South Texas Project Electric Generating Station P.O. Box 289 Wadsworth, Texas 77483

November 1, 2010
U7-C-STP-NRC-100244

South Texas Project
Units 3 and 4
Docket Nos. 52-012 and 52-013
Response to Request for Additional Information

RAI 02.04.12-44, Revision 1

Figure 1: Run 201 areas of “flooded cells” shown by areas of negative depth to water.

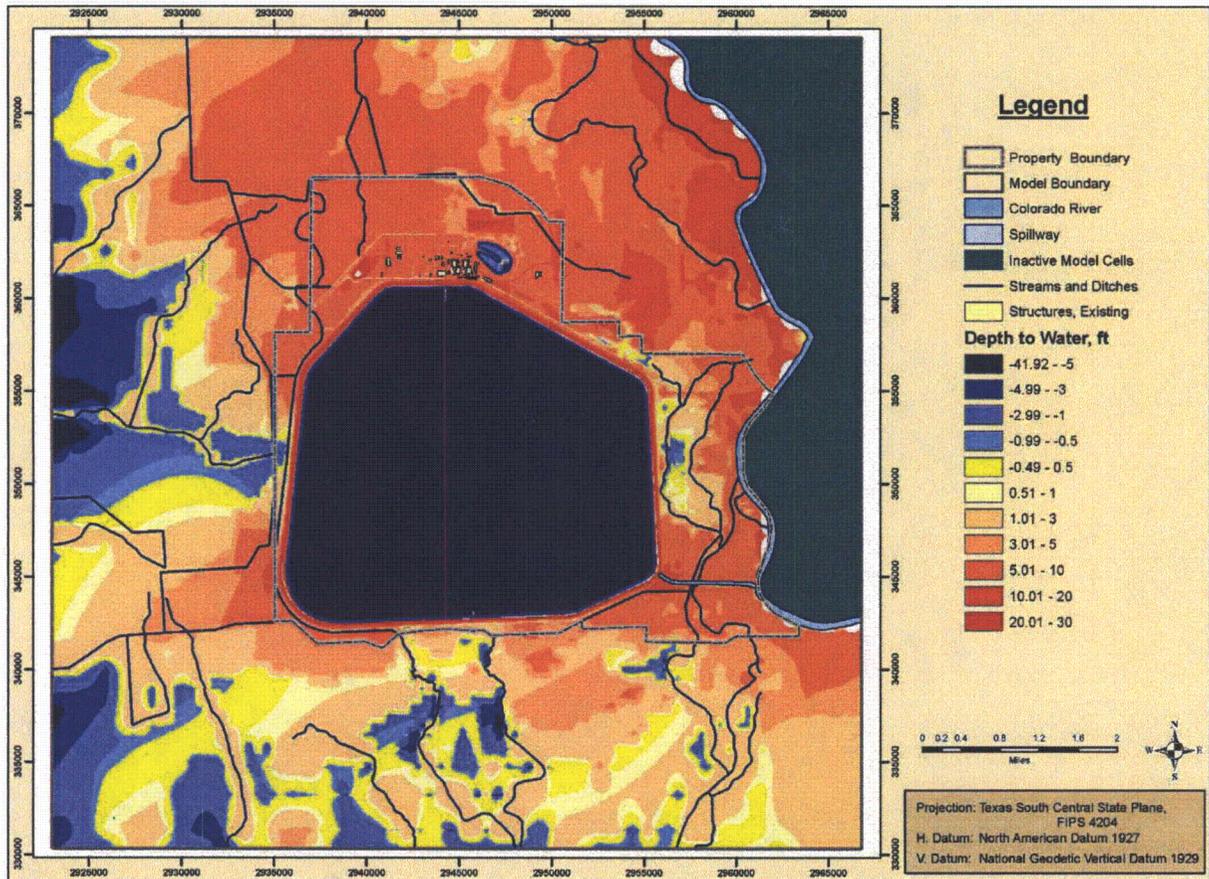
To meet the requirements of 52.79(a) and assist staff in its analysis, additional information concerning the groundwater modeling and the influence of the flooded cells is required. Describe the potential influence of flooded cells in model results. The manually calibrated model (run 201) presents relatively large areas in the western and southern side of the model exhibit flooding (hydraulic head above the specified land surface). Where flooding of cells is indicated, are the model results reasonable given the hydrologic system?

The manually calibrated model (Run 201) does exhibit relatively large areas where the simulated heads are above the model topography along the western and southern portions of the model (Figure 1). Although there is some swamp land in the south portion of the model, the presence of the majority of "flooded cells" is not believed to be representative of the given hydrologic system based on the Blessing SE, TX (Reference 1) and Palacios NE, TX (Reference 2) Quadrangle 7.5 minute series topographic maps. Given the information provided by these two maps, the topographic representation used in Run 201 outside of the STP site boundary was re-evaluated, resulting in refinement to the topography used in the groundwater model. Further re-evaluation of the western general head boundary (GHB) was conducted through a series of sensitivity analyses that resulted in eliminating the majority of the remaining flooded cells in the western part of the model domain.

Figure 1. Location of flooded cells in Run 201.

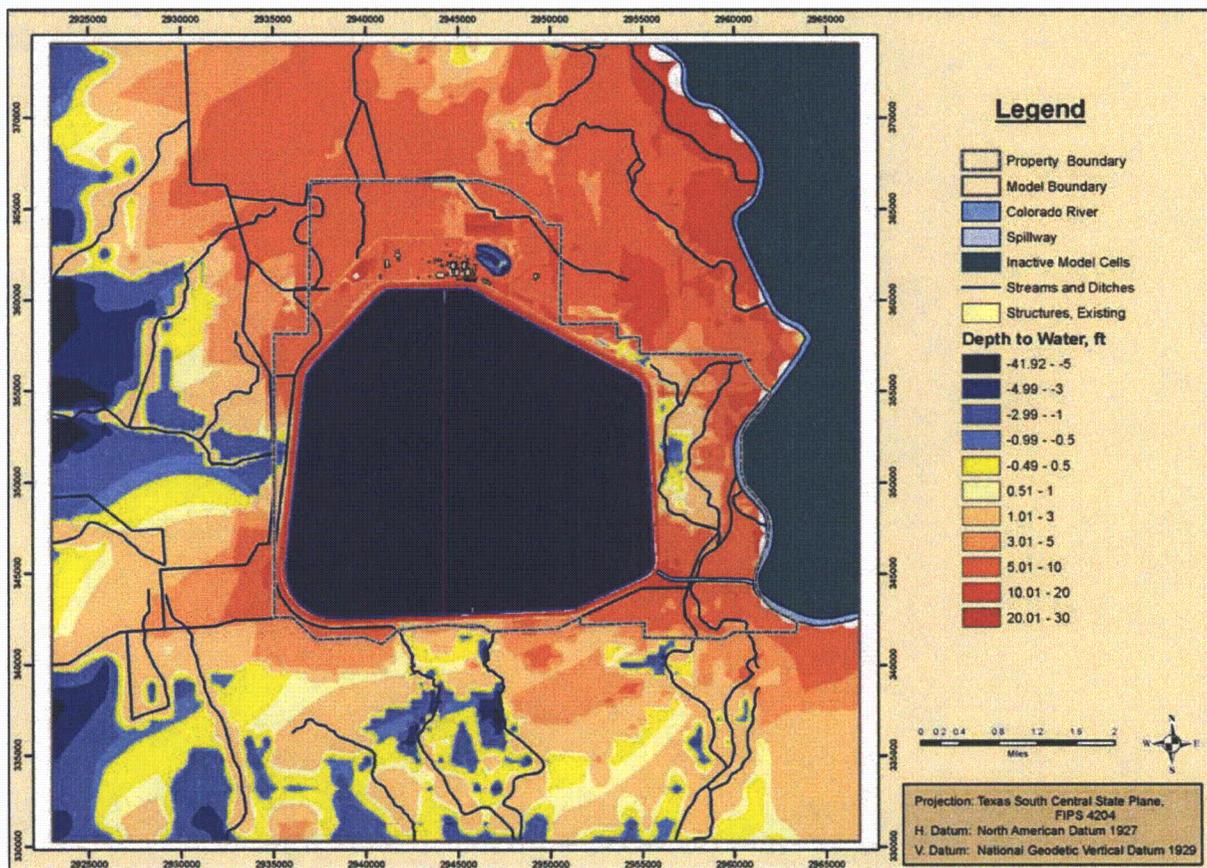
To meet the requirements of 52.79(a) and assist staff in its analysis, additional information concerning the groundwater modeling is required. Staff requests additional information for the groundwater model results and the bands of piezometric contours. The manually calibrated model (run 201) exhibits several rectangular bands of piezometric contours at locations on the south and west sides of the model domain in Layers 1&2. Describe whether these model results are reasonable, or whether they indicate model configuration issues with the drain boundary conditions (e.g., surface elevation, drain boundary conditions)?

The initial response stated that the drain boundaries that represent canals and ditches lower the simulated heads in adjacent cells in model layers 1 and 2 from 10 ft to about 3 ft and from 5 ft to about 0.3 ft along the south domain, and from 22.5 ft to about 13 ft along the west domain. Further analysis of these head differences reveals that flooded cells, which occur along the west and south sides of the model domain (Figure 1), also play a role in the formation of the rectangular bands of piezometric contours. Figures 2 and 3 show the potentiometric surface of layer 1 and layer 2, respectively. Figure 1 shows the location of flooded cells where depth to

groundwater is negative (blue to yellow color spectrum). Comparison of Figure 1 and Figure 2 shows the proximity of the flooded cells to the rectangular bands of piezometric contours.
